RE: **ADDENDUM NO. 3 - RI/FS WORK PLAN  
SUPPLEMENTAL RI  
NORTH MARINA AMERON/HULBERT SITE  
EVERETT WASHINGTON**

North Marina Ameron/Hulbert Site  
 Supplemental RI/FS Work Plan  
 Everett, Washington

**Addendum Number 3  
 Existing and Proposed  
 Soil Sample Locations**

Figure  
**1**

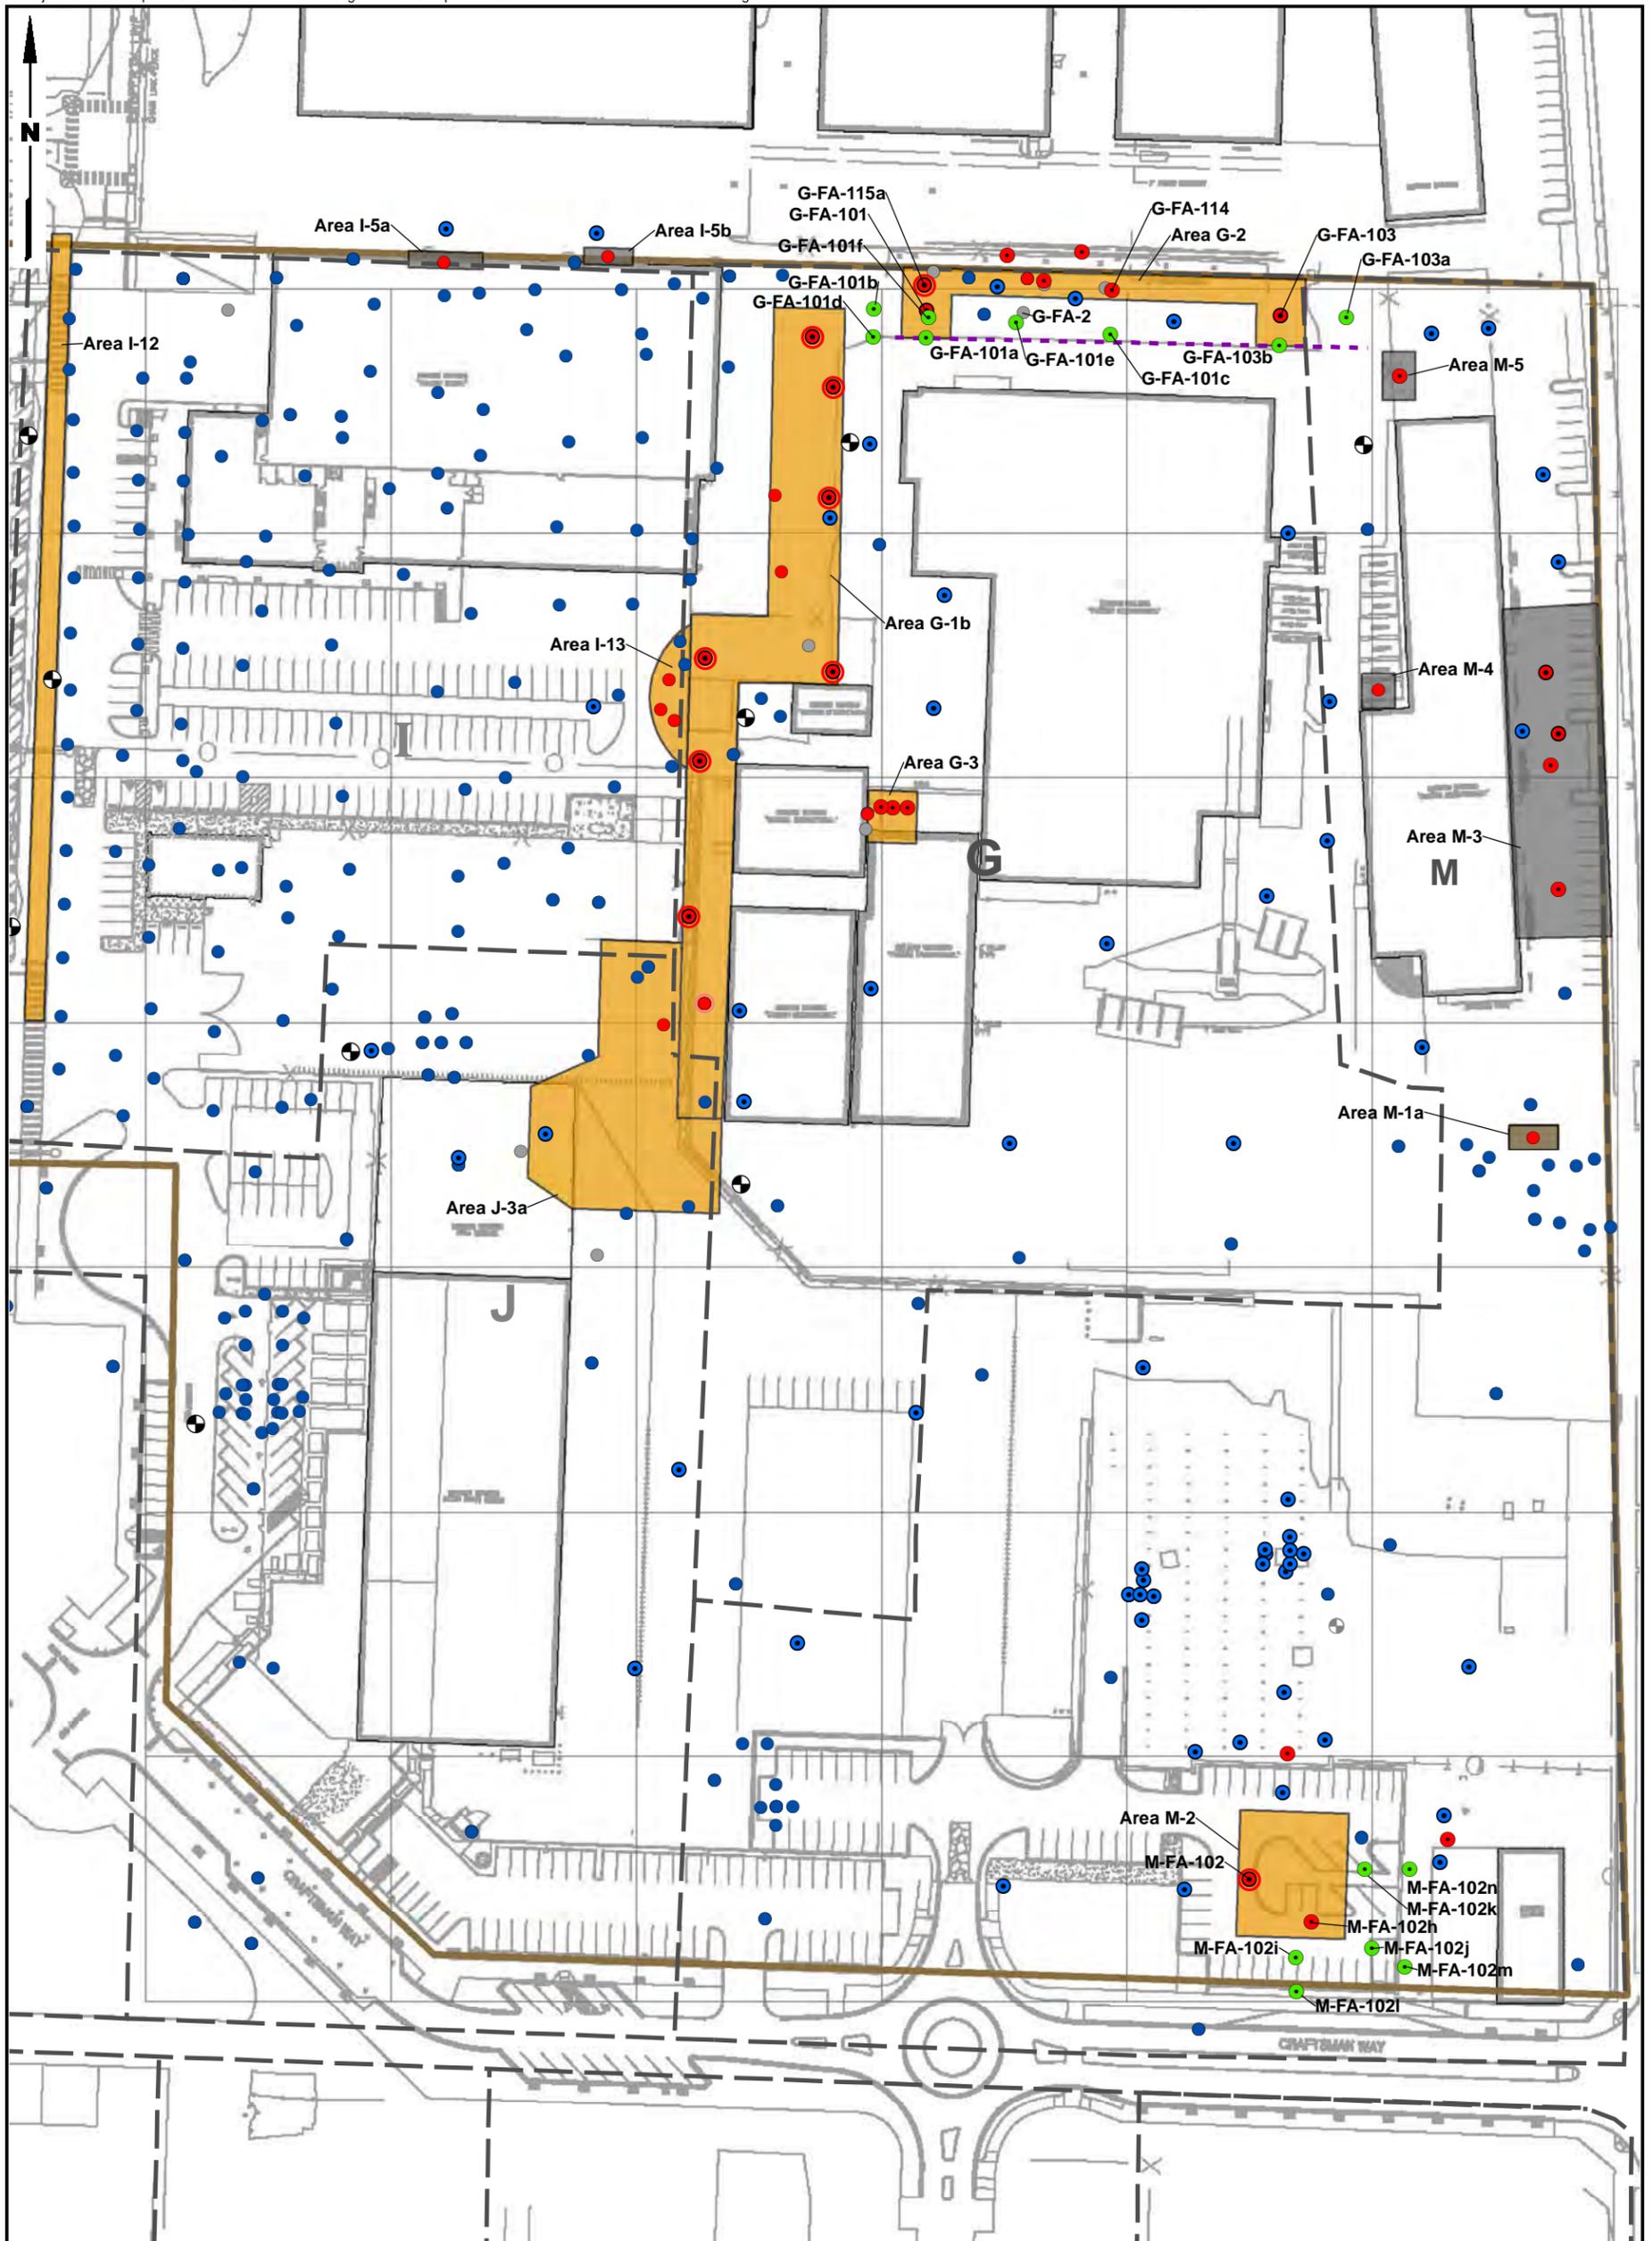
- Advance six soil borings (G-FA-101a, G-FA-101b, G-FA-101c, G-FA-101d, G-FA-101e, and G-FA-101f) in the western portion of Proposed Cleanup Area G-2 to evaluate the horizontal and vertical extent of metals soil contamination in the vicinity of G-FA-101.

- Advance two soil borings (G-FA-103a and G-FA-103b) in the eastern portion of Proposed Cleanup Area G-2 to evaluate the horizontal extent of metals soil contamination in the vicinity of G-FA-103.
- Advance six soil borings (M-FA-102i, M-FA-102j, M-FA-102k, M-FA-102l, M-FA-102m, and M-FA-102n) in the southeastern portion of Proposed Cleanup Area M-2 to evaluate the horizontal extent of metals and cPAHs soil contamination in the vicinity of M-FA-102 and M-FA-102h.

The locations for these additional explorations are shown on Figure 1. Table 1 summarizes the planned depth of exploration, the target sampling intervals, and proposed analyses for each location. Sampling intervals and exploration depths may be modified in the field based on observed conditions. All soil explorations for the Supplemental RI will be advanced using direct-push drilling equipment. Soil samples will be analyzed for the parameters identified below unless field screening (conducted in accordance with the RI Work Plan) indicates additional testing is warranted based on the presence of potential contamination. Blind field duplicate soil samples will be collected and analyzed in accordance with the RI Work Plan. All samples will be collected and preserved consistent with the method-specific requirements presented in Table F-2 for the Final RI/FS Work Plan. Analyses will be conducted within the specified holding times, also presented in Table F-2 of the Final RI/FS Work Plan. In addition, the analyses will be conducted consistent with the quantitation limit goals identified in Table F-3 of the Final RI/FS Work Plan.

Soil borings will be advanced to the south, southwest, west, and southeast of RI borings G-FA-101 and G-FA-115a and to the south and east of RI boring G-FA-103 to determine the horizontal and vertical extent of metals concentrations exceeding the soil screening levels at these locations. Soil borings G-FA-101a and G-FA-103b will be advanced to the south of G-FA-101 and G-FA-103, respectively, approximately 5 ft north of the 1973 pavement line (Figure 1). Soil borings G-FA-101b and G-FA-101d will be advanced at the western limits of the Area G-2 boundary, approximately 30 ft from G-FA-101, and boring G-FA-103a will be advanced at the eastern limit of the Area G-2 boundary, approximately 30

ft from G-FA-103. Soil boring G-FA-101c will be advanced to the south of RI boring G-FA-114, about halfway between G-FA-101a and G-FA-103b, to confirm that Area G-2 is adequately bounded to the south. Soil boring G-FA-101e will be advanced adjacent to boring G-FA-2 because no analytical data was collected from the G-FA-2 boring. An additional boring (G-FA-101f) will be advanced directly adjacent to G-FA-101 to confirm the vertical extent of silt-like material observed to 10 ft below ground surface (BGS) at that location.

Soil borings will be advanced to the south, east, and southeast of M-FA-102 and M-FA-102h to better delineate the horizontal extent of metals and cPAHs concentrations that exceed the screening levels at these locations. Soil borings M-FA-102i, M-FA-102j, and M-FA-102k will be advanced near the estimated southeast limits of Area M-2, as shown on Figure 1. Step-out soil boring M-FA-102l will be advanced south of M-FA-102i, at the estimated Site boundary. Step-out borings M-FA-102m and M-FA-102n will be advanced southeast of M-FA-102j, and east of M-FA-102k, respectively, just east (outside of) of the current edge of the parking lot pavement.
